CALIFORNIA COASTAL COMMISSION

**STAFF REPORT: REGULAR CALENDAR**

APPLICATION NO.: 4-99-211

PROJECT LOCATION: 28827 Grayfox Street, City of Malibu, County of Los Angeles

EXHIBIT NO. 4
APPLICATION NO. 4-99-211
Site Plan

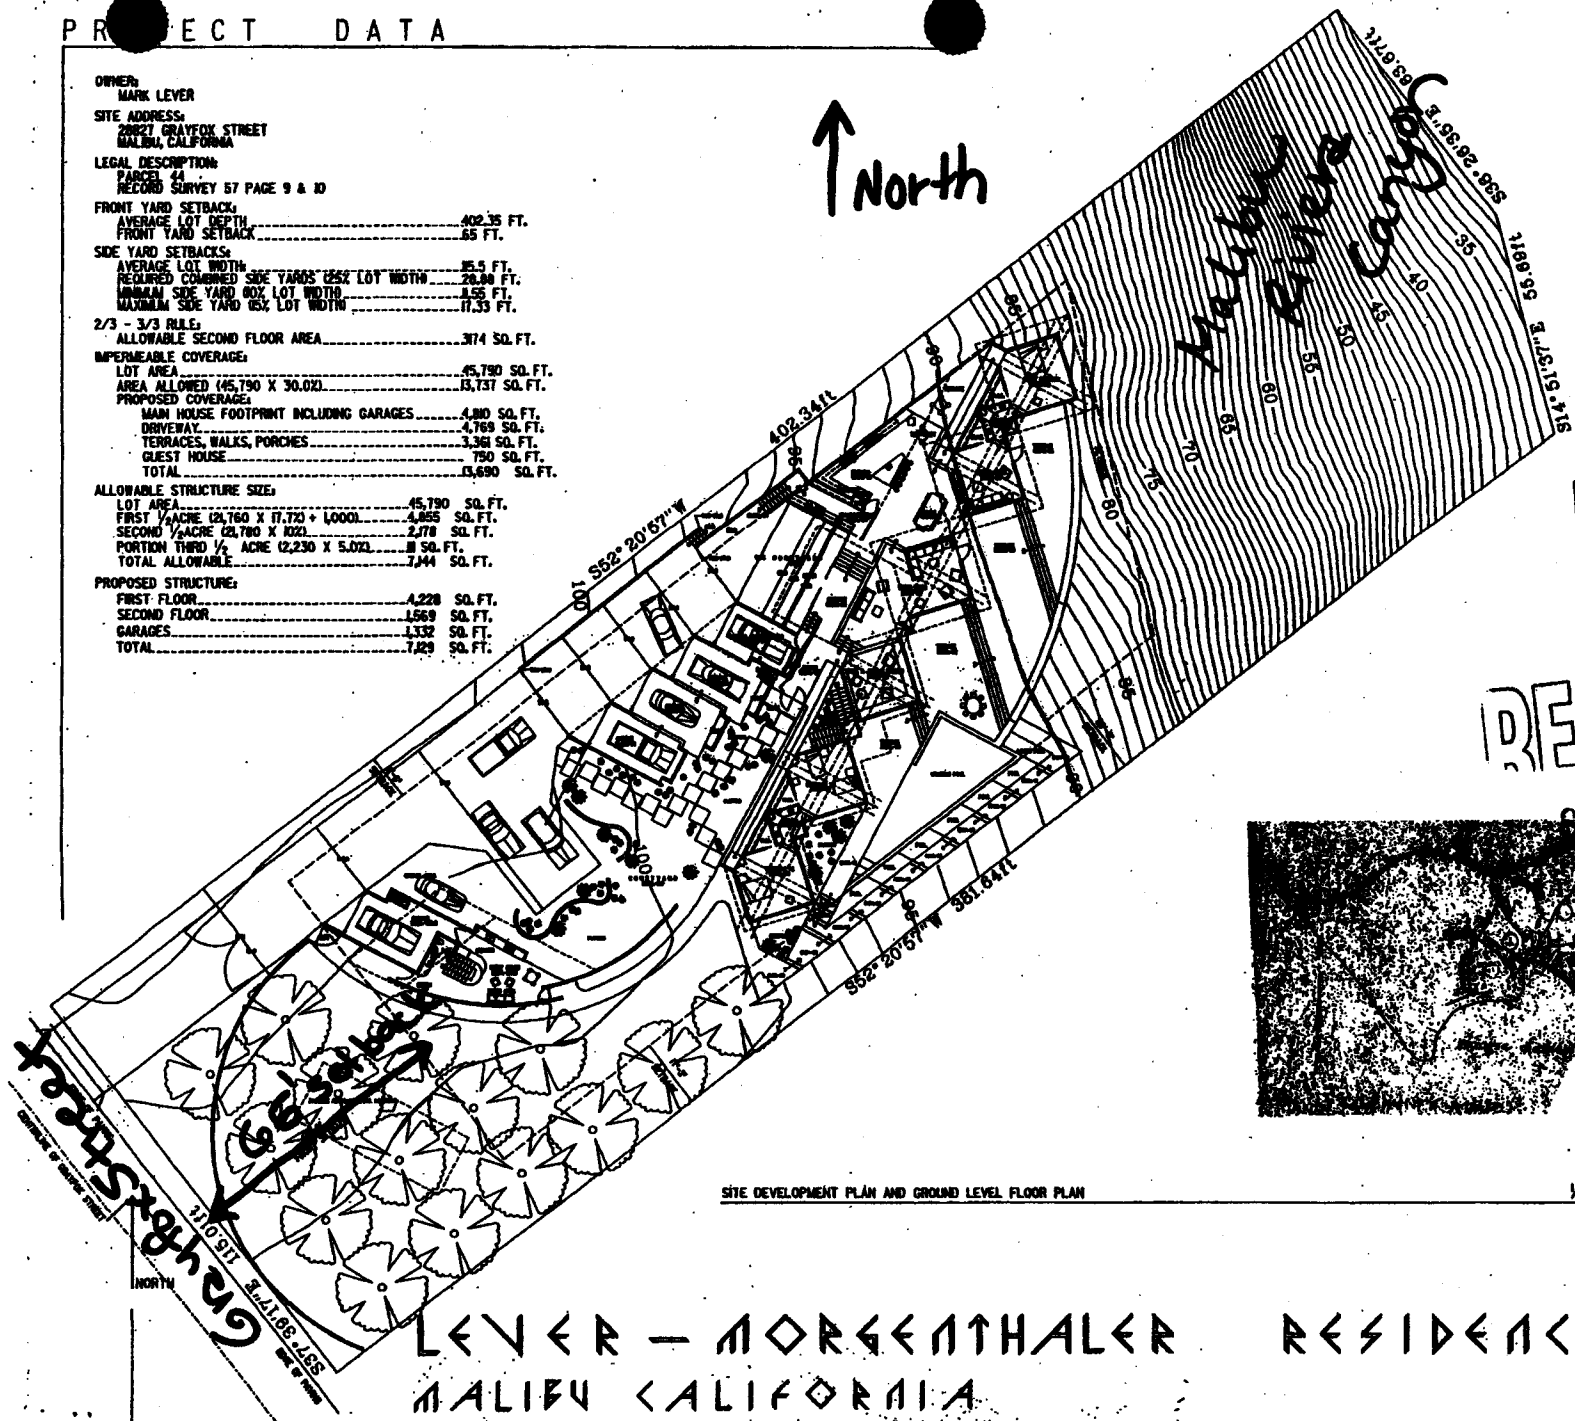
Construction on the slope is not necessary to achieve an adequate development envelope on the subject site. Commission staff has determined that one or more feasible alternatives exist that would protect the canyon slopes and provide for the construction of a residence, albeit of a different design, and that such alternatives could be favorably considered under the Chapter 3 policies of the Coastal Act.

A large, nearly level pad area is situated immediately adjacent to the site entrance off Grayfox Street. The project plans conceptually approved by the City of Malibu show a front yard setback from Grayfox Street of 65 feet. This setback removes over 5,250 square feet of level building area from the applicant's available building footprint. Returning part of the area captured by this rather deep setback to the area available for construction would facilitate the redesign and relocation of the proposed residence away from the canyon slope, thereby protecting the canyon's environmentally sensitive habitat.

To illustrate the effect a change in the frontyard setback would have on the available development envelope on the subject site, the Commission estimates that if the applicant obtained a variance to reduce the present 65-foot front yard setback to a more moderate 25-foot setback (though this represents a slightly greater reduction than the approximately 32-foot setback that could be authorized administratively by the City staff), and retained the existing total of approximately 28 feet of combined sideyard setbacks (25% of lot width as required by the City), and if the footprint of the proposed development was relocated to a minimum of 100 feet streetward (south/southwest) of the 90-foot contour (top-of-slope), thereby avoiding fuel modification and other adverse impacts upon the canyon's sensitive habitat, the applicant would still have a remaining potential building footprint of approximately 11,700 square feet. As noted in further discussion below, an alternative has also been identified that would setback the project only 50 feet from the 90-foot contour, thus increasing the potential alternative building envelope by approximately 6,000 additional square feet and thereby producing a more-than-adequate potential building envelope of at least 17,000 square feet.

EXHIBIT NO. 13a
APPLICATION NO. <u>Level</u>
<u>4-99-211</u>
<u>"Top-of-Slope"</u>

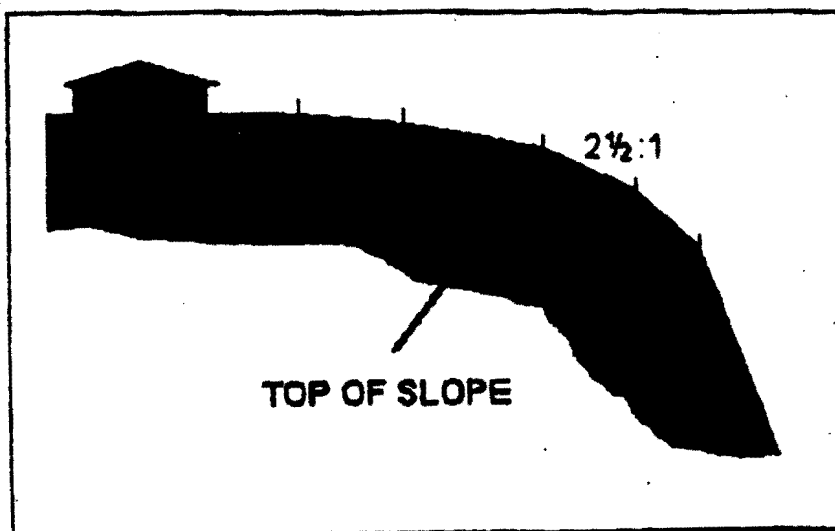
The certified LUP maps show the boundary of the disturbed sensitive resource area at approximately the 90-foot elevation line along the upper edge of Malibu Riviera Canyon, which coincides with the slope's increasingly steep descent into the canyon. As can be seen on Exhibit 6, the parcel is of relatively low relief until approximately the 90-foot elevation line, which Commission staff believes represents the top-of-slope.
